Work Order ID 101366

Item Name: Crosstube Turning Detail

DART AEROSPACE LTD		Work Order: 101366
Description: Crosstube Assembly (205/212/412 High Fwd)		Part Number: D212-664-141
Inspection Dwg: D212-664-141 Rev: D		Page 1 of 2

DRAWING NO. D212-664-141	TITLE XTUBE ASSY (205/212/412 HI FWD)	REV. D	DART AEROSPACE LTD ENGINEERING ORDER		D.E.O. NO. D212-664-141-D-1	SHEET NO. SHEET 1 OF 2	SCALE NTS
DRAWN	CHECKED	<i>RP</i>	MFG. APPR.	<i>RE</i>	APPROVED	<i>MP</i>	DE APPR.
DATE 11.04.07	DATE 11.07.11		DATE 11.04.12		DATE 11/04/12		DATE 11.04.12

**D212-664-141/-141B
ASSEMBLY DETAIL**

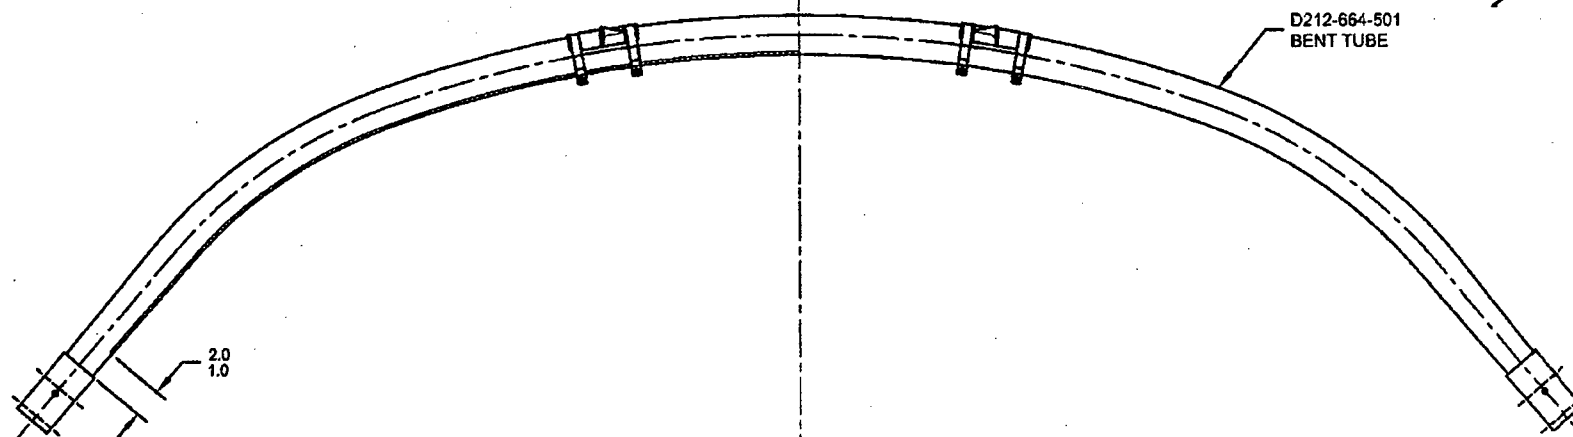
PURPOSE:

ADD AN INSPECTION WINDOW TO UNDERSIDE OF CROSSTUBE.

IS:

WAS:

MASK AREA PRIOR TO PAINTING.
REMOVE MASKING AFTER PAINT
AND APPLY CLEAR COAT
